## **Determination 2006/52**

# **Single means of escape from a high-rise apartment building at 18 Turner Street and 17-19 Waverley Street, Auckland City**

**Figure 1: Typical plan of Waverly Tower**

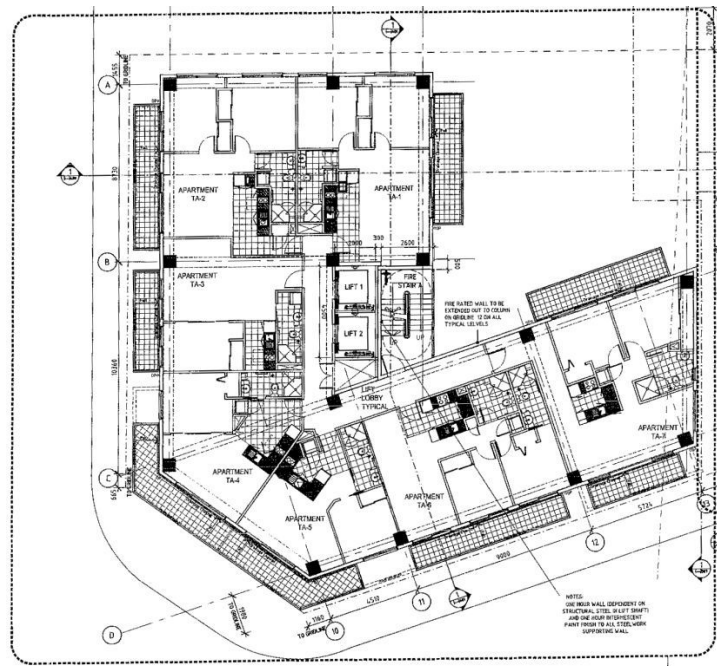
5.3.1 The experts described the buildings in relation to their fire safety aspects and noted that the escape routes from both the Waverly tower and the Turner tower were unorthodox in their design. Taking into account this factor, the experts established that the escape height for Waverly tower was 41 metres and that for the Turner tower it was 38.4 metres. The experts described the features that the designers had introduced that were enhancements to the buildings and which were considered as being significant in the preparation the experts' report. These were:

- a sprinkler system with a Class B dual water supply, instead of a Class C single water supply
- the stair in each tower being open on one side and while these are not external stairs, there is a benefit. However, this benefit is less than that subjectively assumed in the fire reports
- the stair egress widths being 1200mm wide rather than 1000mm wide.

- a corridor pressurisation system is to be designed, installed, and commissioned to the satisfaction of the territorial authority, with particular attention paid to air relief
- doors are not to be locked from the stairwell side in a manner that would prevent occupants from being able to enter any floor level from the stairwell in fire alarm conditions
- in the absence of automatic smoke detectors, tamper-proof manual-call points are to be provided in the stairwells
- appropriate signage is to be included to the satisfaction of the territorial authority, indicating that the escape route descends past the ground floor entry in each tower to the first basement level
- the fire engineer is to monitor construction and provide a "Producer Statement of Construction Review" to the satisfaction of the territorial authority.

**Figure 20:** Case 1 "As submitted" (a) Risk profile and (b) Risk margin (0%), the x-axis is risk of fatality given an apartment fire

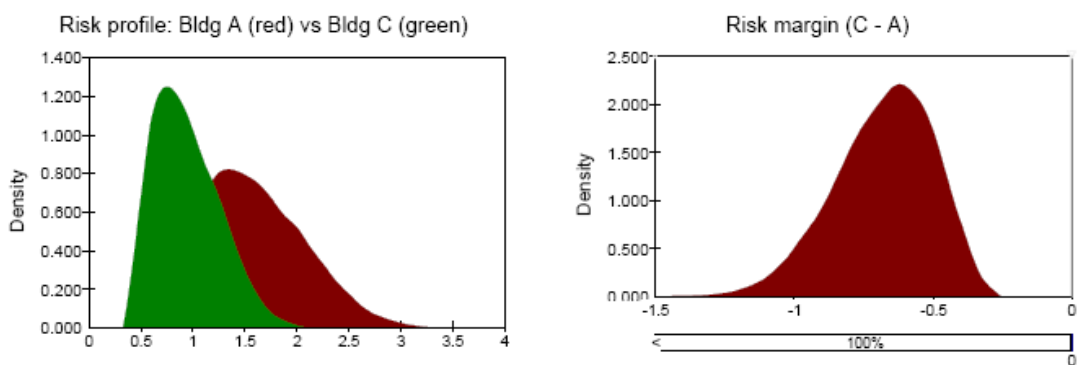
In the submitted Case 1 scenario, the small increase in sprinkler reliability enhancement for Building A does not compensate for the lack of a second stair.

6.6.1.3 These results show that Case 1 as submitted in the fire reports does not pass the comparative evaluation analysis, while the experts' recommended Case 2 scenario does.

**Figure 21:** Case 2 "As recommended" (a) Risk profile and (b) Risk margin (96%), the x-axis is risk of fatality given an apartment fire

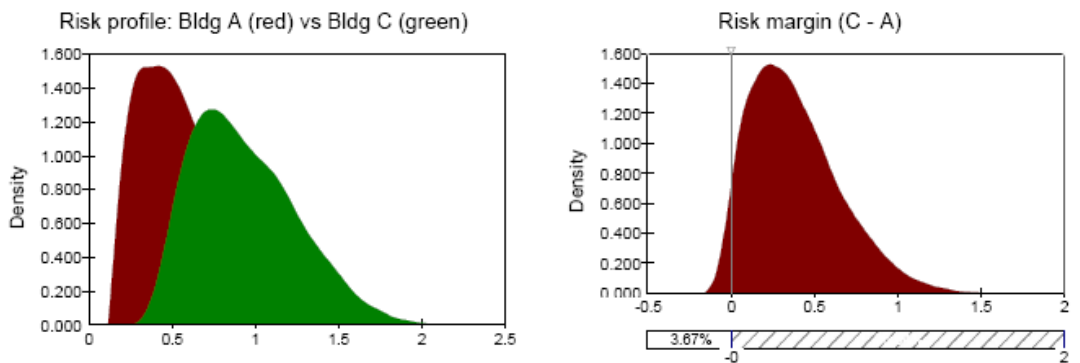
In the recommended Case 2 scenario, the corridor pressurisation system added to Building A protects the stair from smoke spread and provides improved safety to the occupants on the same floor as the apartment of fire origin.

- 7.2.2 The experts have indicated a comparative margin in the base case plus the inclusion of a corridor pressurisation system of 96%, which clearly exceeds a target range of 50% to 75%, set by other determinations, such as Determination 2005/109 *et al.*
